ZONING DRAINAGE REPORT

Villages at Troon Phase 3

ZONING DRAINAGE REPORT COMMENT RESPONSE

Subject: Villages at Troon Phase 3
Zoning Drainage Report Review
Case number: 27-ZN-2016

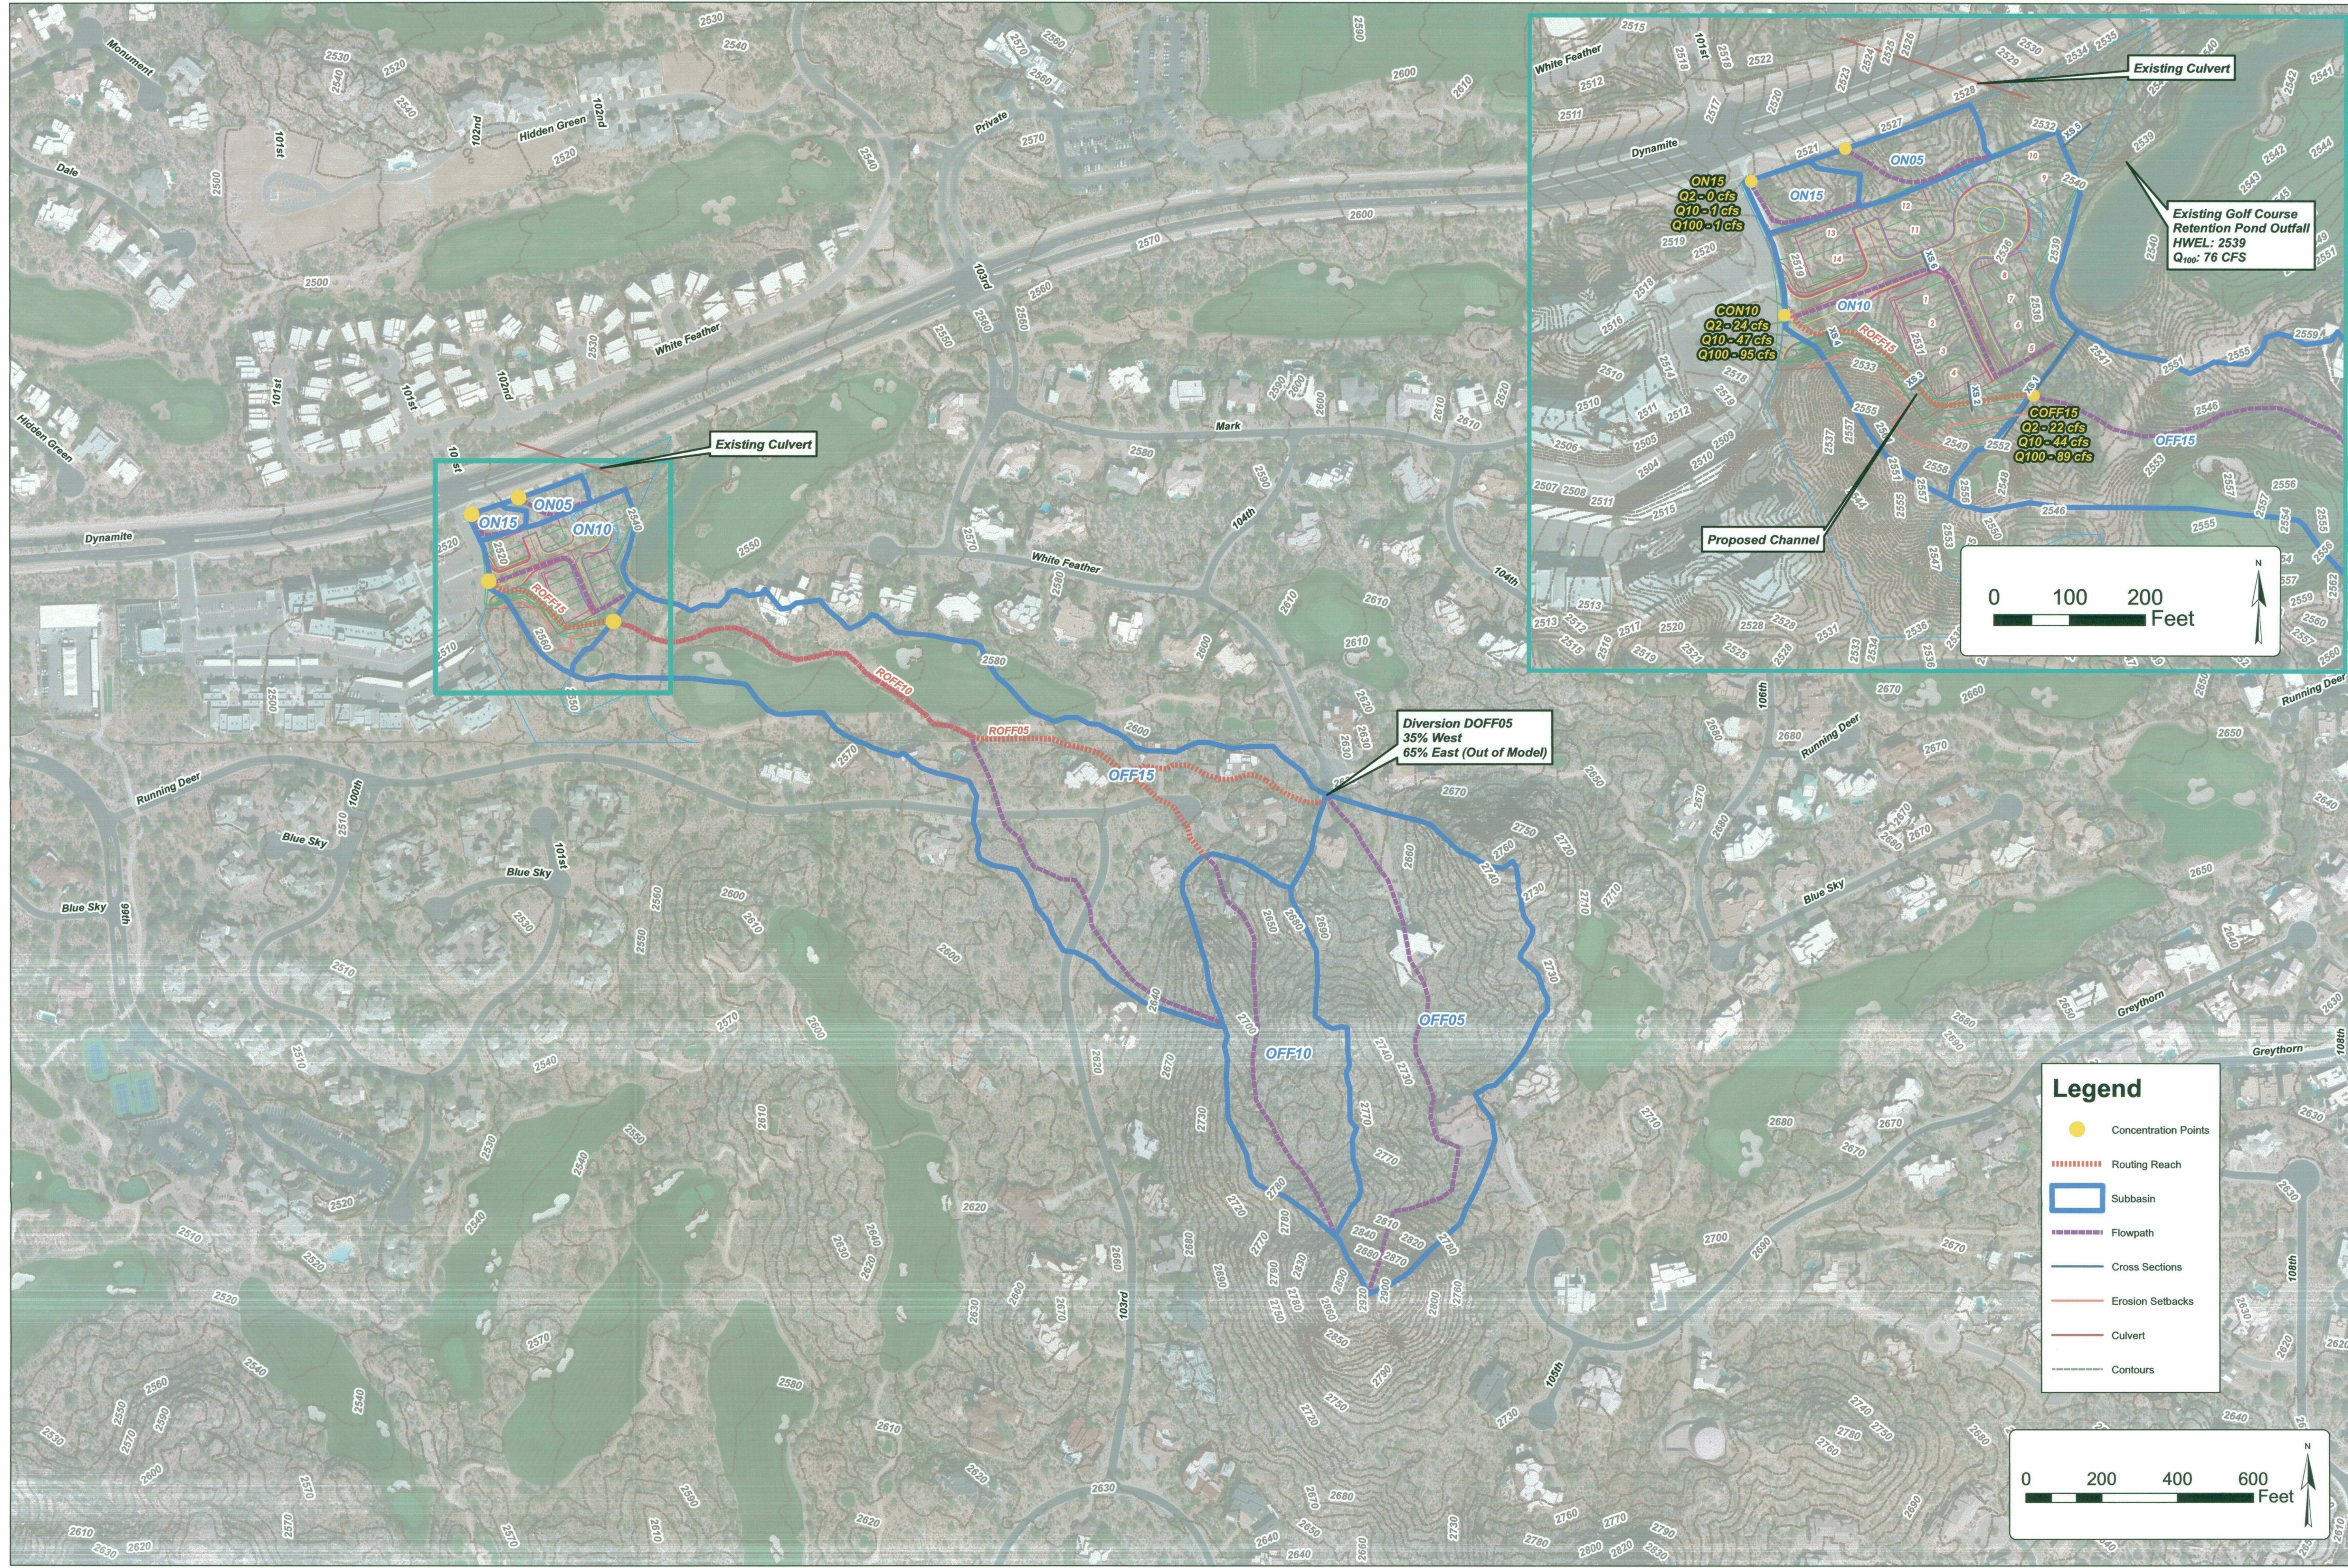
4. HEC-1 model shall provide discharge analysis for the 2, 10, and 100-year events. Clearly depict pre and post development discharges on the plan.

8. Lateral erosion setback analysis is required. Please note, minimum setback for straight and curved wash reaches is 20' and 50', respectively.

Outputs for the 2, 10, and 100-year events are provided in Appendices A and B for existing and proposed models, respectively. See Figures 3 and 4 and the "Proposed Onsite Hydrology" section of the report for a summary. Discharges are also indicated on the plan.

A lateral erosion setback analysis has been performed. See Figure 4 and section "Proposed Onsite Hydraulics" of the report. Erosion will be mitigated with a rock riprap lined channel.
